Quality Control Report

Consultant	Wahib Medanat Consultant Engineers	Rep No.	QC-12 03
Site Name	Al Khansa'a Basic Mixed - Balqa	Date	18 / 04 / 2
Package	Package 1		
Contractor	Derar Saraireh & Sons for Engineering & Contracting		
Tender No.	1/2020/USAID/SKEP/3/1

Schools for Knowledge Economy Project SKEP III

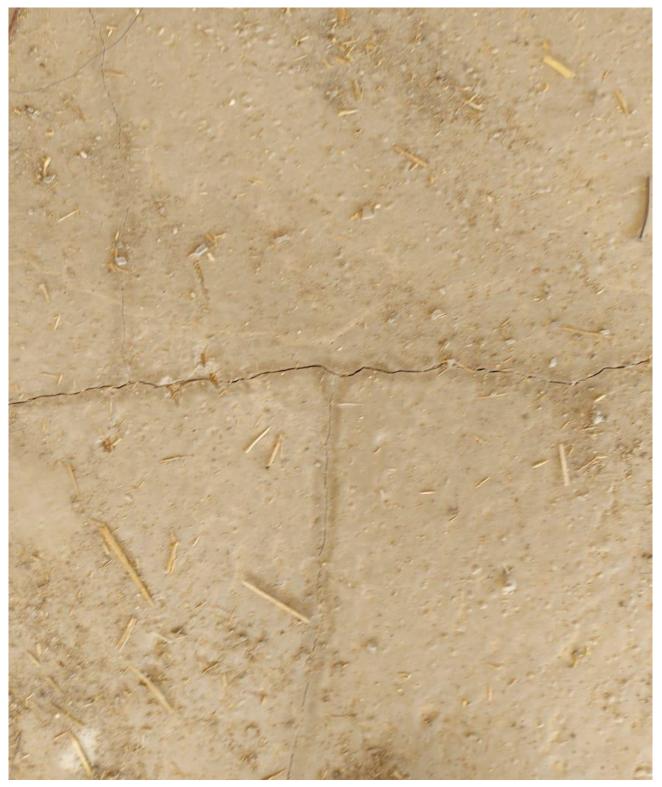
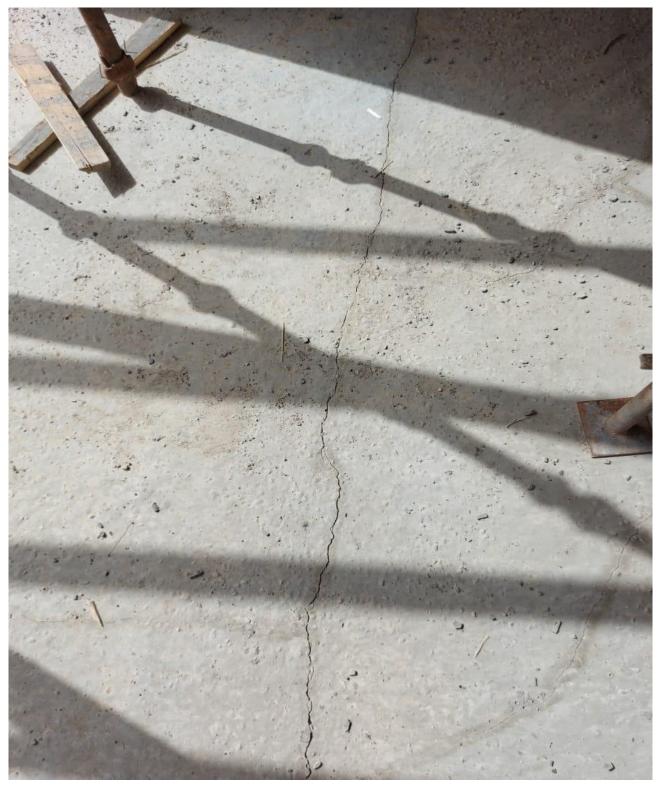
Description of Non- Conformance	Corrective Action	Required by / When
Hair cracks in the slab on grade and the slab of the sewage collection tank.	Repair using approved repair material and avoid cracks in the future casting by more attention to be taken for curing using burlap in hot weather.	Immediately by Contractor.
Report Prepared by	Hassan Shaqbua, Supervision Quality Control Manager

The Contractor has not started yet with the remedy work. He provided burlap for next concrete casting.
